Access Compliance Report

Public Rights-of-Way

(Curb Ramps)

Intersection ID: 10032717	Main Street: N_POPLAR_ST	Cross Street: N/A	Location: W
ADA ID: D26C15E2D011	Ramp Type: Directional1	Initial Pass/Fail: Fail	Overall Compliance: No
			Severity Score: 13.75

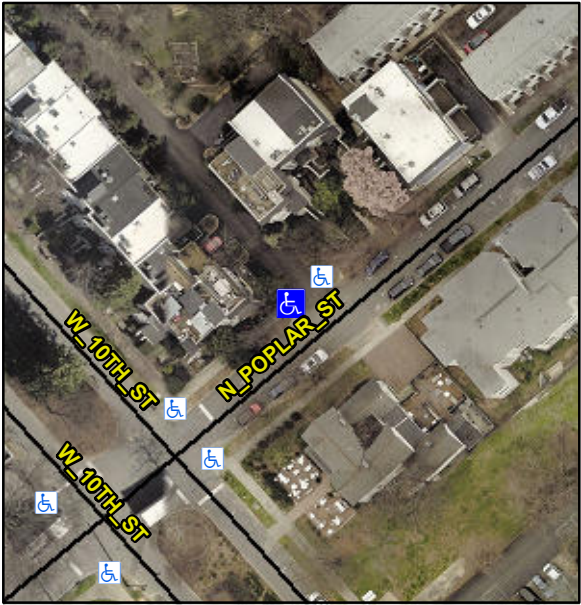
Codes/Mitigation Info/Possible Solution			Field Measurements/Component Compliance			
	Possible Solutions:		Compliance	Description	Data	
	Remove & Replace Entire Ramp.		N/A	Ramp Length (in)	51.0	N/A
			Yes	Ramp Width (in)	63.0	N/A
			No	Ramp Slope (%)	10.8	N/A
			No	Ramp XSlope (%)	2.8	N/A
			N/A	Flare Type LT	N/A	N/A
			N/A	Flare Slope LT (%)	N/A	N/A
			N/A	Flare Traversable LT?	N/A	N/A
			N/A	Flare Type RT	N/A	N/A
			N/A	Flare Slope RT (%)	N/A	N/A
<p>Surveyor Notes:</p> <p>N/A</p>			N/A	Flare Traversable RT?	N/A	N/A
			N/A	Landing Length (in)	0.0	N/A
			N/A	Landing Width (in)	0.0	N/A
			N/A	Landing Slope (%)	0.0	N/A
			N/A	Landing X Slope (%)	0.0	N/A
			N/A	Landing Curb? (Y/N)	N/A	N/A
			N/A	Shared Landing?	N/A	N/A
			N/A	Gutter Ponding?	0.0	N/A
			N/A	Gutter Lip Ht (in)	0.0	N/A
			N/A	Painted X Walk1?	No	N/A
<p>PROW/ADA:</p> <p>R304.2.2, R304.5.3</p>			N/A	X Walk 1 Direction	To NE	N/A
			N/A	X Walk 1 Width (in)	N/A	N/A

N/A	X Walk 1 Slope (%)	4.7	N/A
			N/A	X Walk 1 X Slope (%)	1.9	N/A
			N/A	Ramp inside XWalk1?	N/A	N/A
			N/A	Any Obstructions?	N/A	N/A
			N/A	Obstruction Type		N/A
			Yes	Surface Condition? (G/P)		Good
			N/A	Curb Slope (%)		3.7
Street 1 Name	ENTRANCE					
Stop Condition-Street 1	StopSign					
Street 2 Name	N/A					
Stop Condition-Street 2	N/A					
Total Cost:	\$	1600.00
